Tesla, Inc. Service Bulletin		<i>Inspect Charge Port Busbar Safety Cap And Protective Earth Busbar</i>	
SB-20-44-002 July 24, 2020			
Classification		Section/Group	Mobile Service
Campaign Bulletin		44 - High Voltage System	Can Perform (where permitted)
Model Year	Model	Country/Region	Version
2020	Model Y	North America	All
<small>The model(s) and model year(s) listed are a general approximation of the affected VIN list. Refer to the VIN/Bulletin Tracker or Customer/Vehicle profile to determine applicability of this bulletin for a particular vehicle.</small>

Some Model Y vehicles were manufactured with a charge port busbar safety cap and/or PE (Protective Earth) busbar that might not meet internal specifications, resulting in intermittent vehicle charging capability.

Figure 2

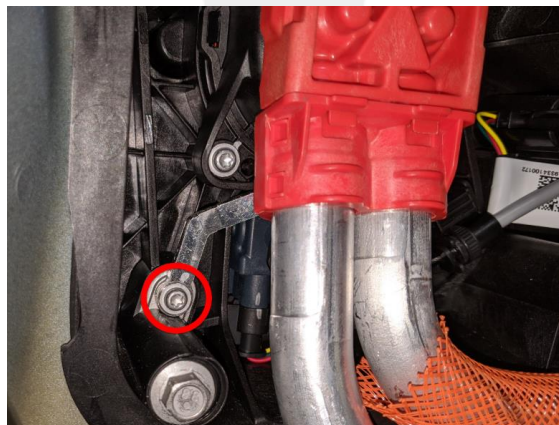
3. Remove the LH C-Pillar bracket (refer to Service Manual procedure [15186402](#)).
4. Perform a torque check on the screw that attaches the PE busbar to the charge port carrier (torque 3.0 Nm) (Figure 2).

- If the screw cannot be properly torqued, or if there is damage to the PE busbar/charge port bolt threads:
 - a. Replace the charge port (refer to Service Manual procedure [44011602](#)), but return to this procedure after performing the resistance test between the charge port busbar lead and charge port busbar stud.
 - b. Skip to step 11.
- If the screw can be properly torqued, and there is no damage to the PE busbar/charge port bolt threads, continue to step 5.

Figure 5

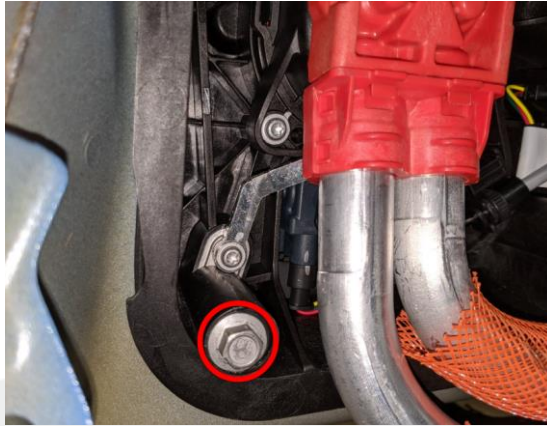
10. Perform a torque check on the bolt that attaches the charge port carrier ground to the body (torque 5.5 Nm) (Figure 5).

Figure 8

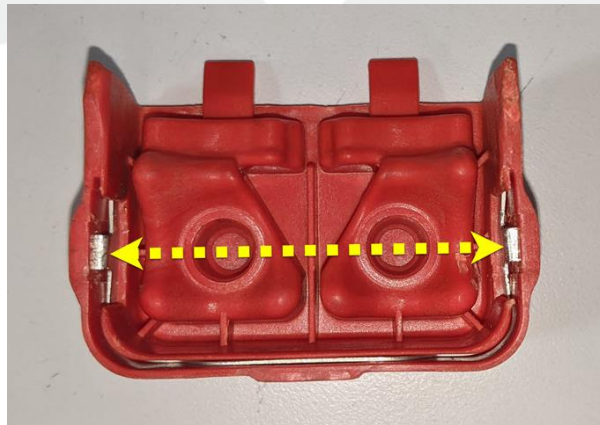
15. Using digital calipers, measure the distance between the electrical terminals on the underside of the charge port busbar safety cap (Figure 8).

- If the distance between the two terminals is less than 45.94 mm, remeasure the distance. If the measurement is still less than 45.94 mm, continue to step 16.
- If the distance between the two terminals is between 45.94 mm and 46.24 mm, continue to step 16.
- If the distance between the two terminals is greater than 46.24 mm:
 - a. Use needle nose pliers and a pocket screwdriver to equally bend both terminals toward the center of the charge port busbar safety cap.
 - b. Remeasure the distance between the terminals and continue to step 16 when the measured distance is between 45.94 mm and 46.24 mm.

**NOTE:** If the terminals are damaged, or if unable to properly rework the terminals, procure a new charge port busbar safety cap, and then continue to the step 16.
